**RE: Aggregate Resources Act Application – Proposed Harrington Pit
Comments Provided by Dr. Larry Jensen, November 8, 2024**

This letter provides information and analysis to respond to groundwater related comments provided by Dr. Larry Jensen in his email package directed to Harrington McAvan Ltd , ARA Approvals and, MNR hydrogeologist (Oleg Ivanov), dated November 8, 2024.

1000394952 Ontario Inc.
Proposed Harrington Pit

Figure 1: Drilling Locations

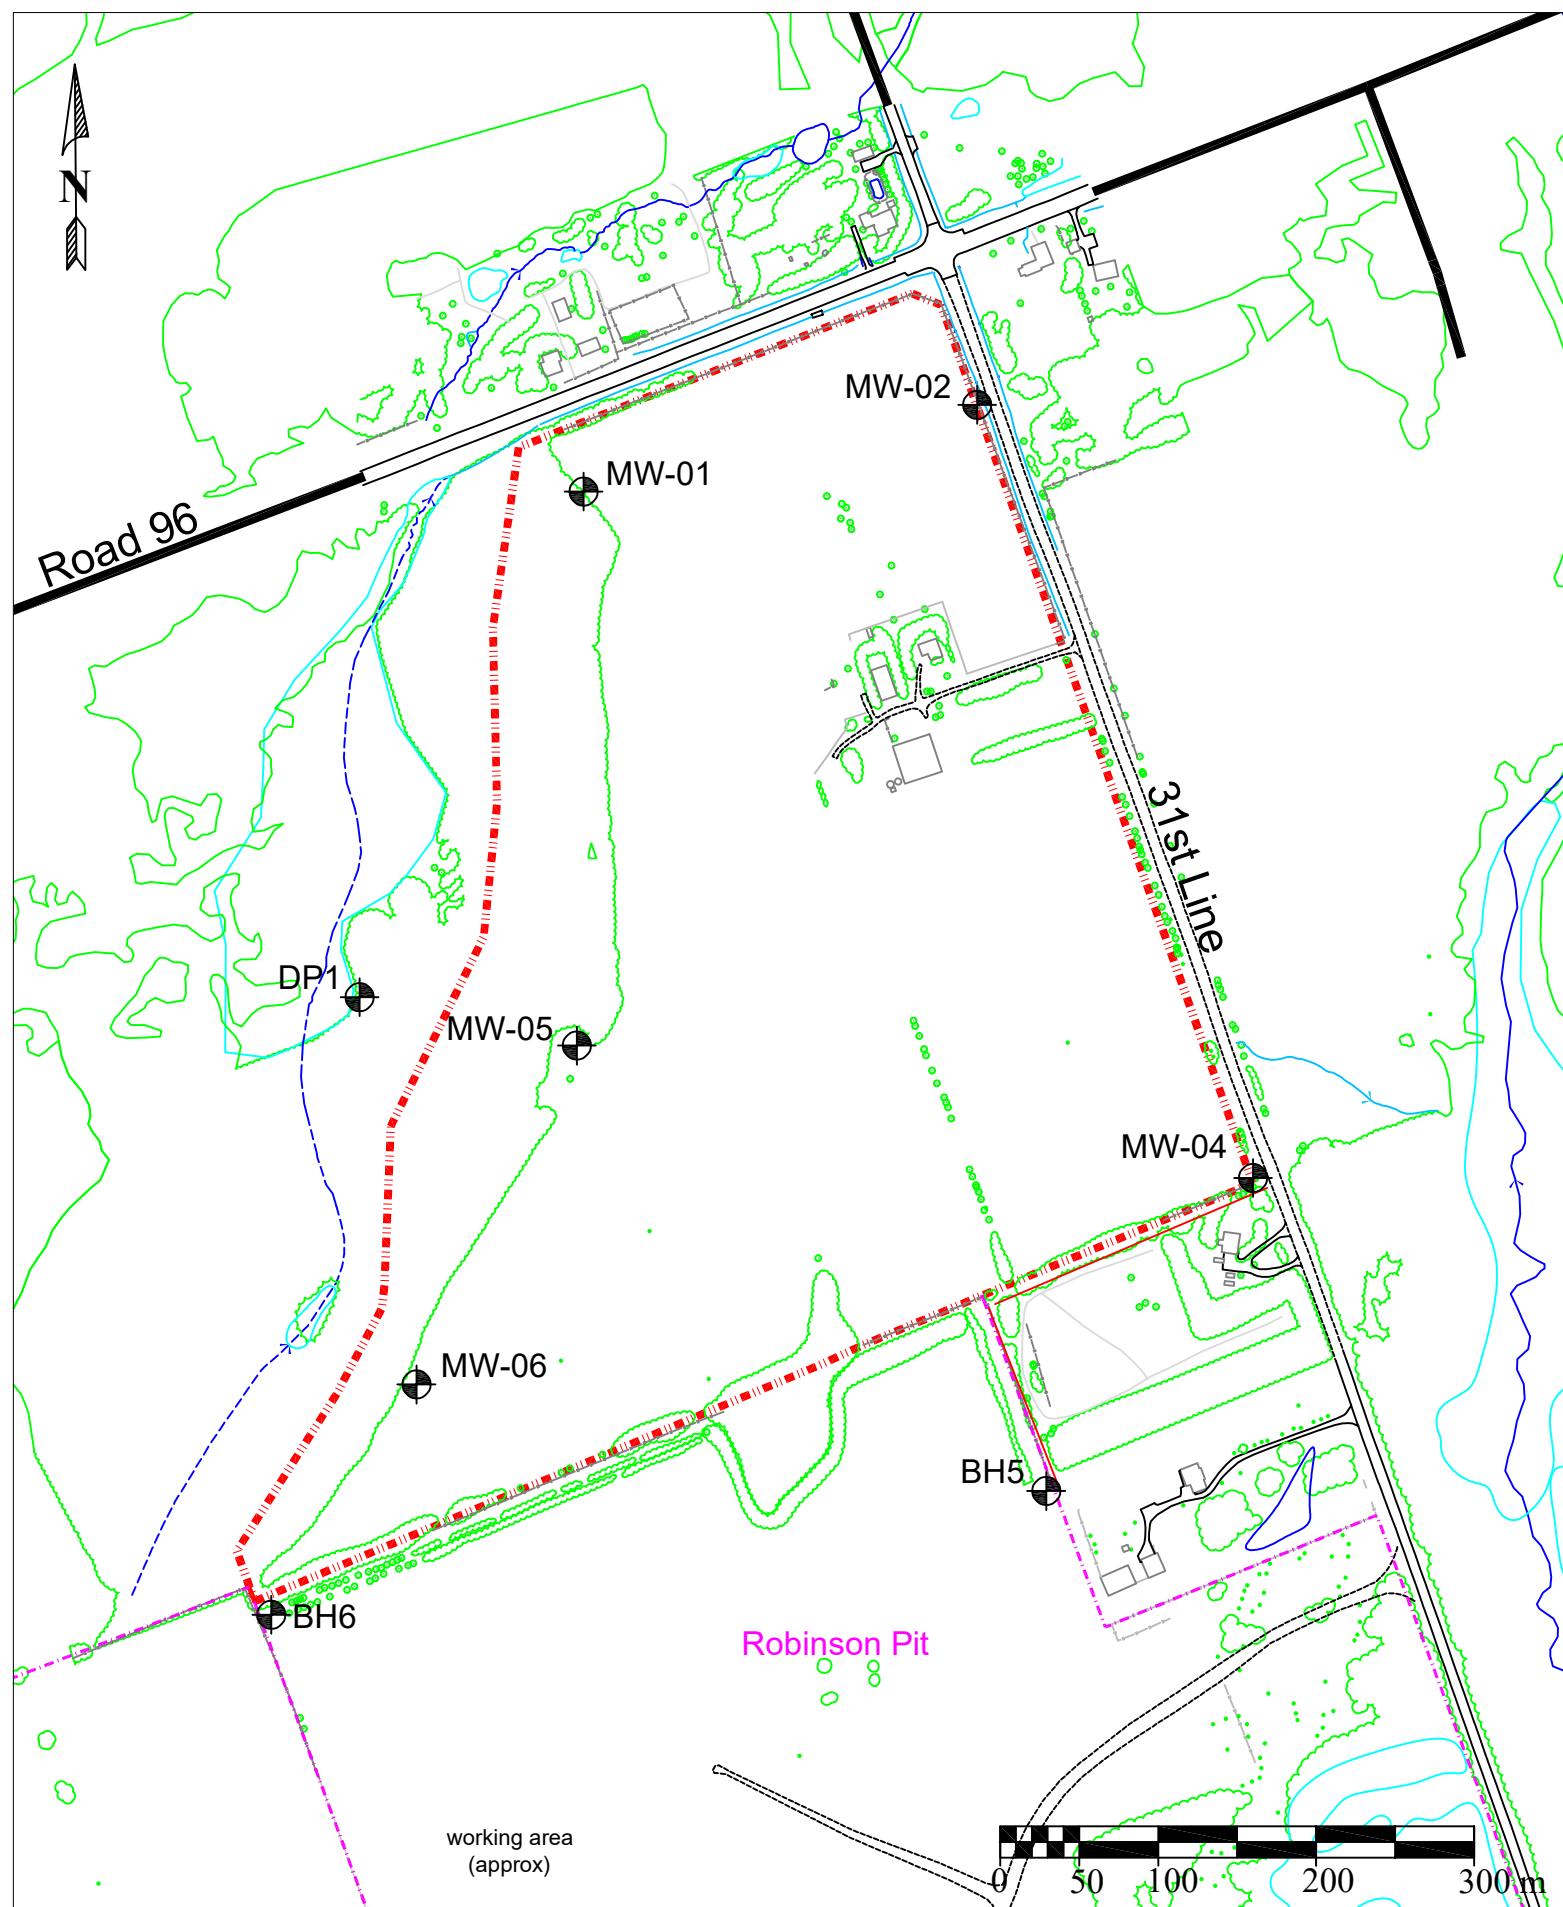
Dr. Jensen questions the number and location of monitoring wells constructed at the site and suggests the monitoring network is insufficient. We note that two additional monitoring wells were installed at the site in January 2025 at the request of MNR. The wells were requested to improve the interpretation of groundwater – surface water relationship between the site and the western valley and drainage system, and, provide additional confirmation of water table elevations across the proposed extraction area.

The new monitoring well locations, referenced as MW-05 and MW-06, are shown on the attached figure. The wells were drilled by SD Hopper Drilling using the reverse (air) rotary method, which is typically used for water supply or geothermal well installations. This method was chosen to overcome the difficult drilling conditions (interpreted presence of boulders at depth) encountered with previous environmental (hollow stem auger) drilling programs.
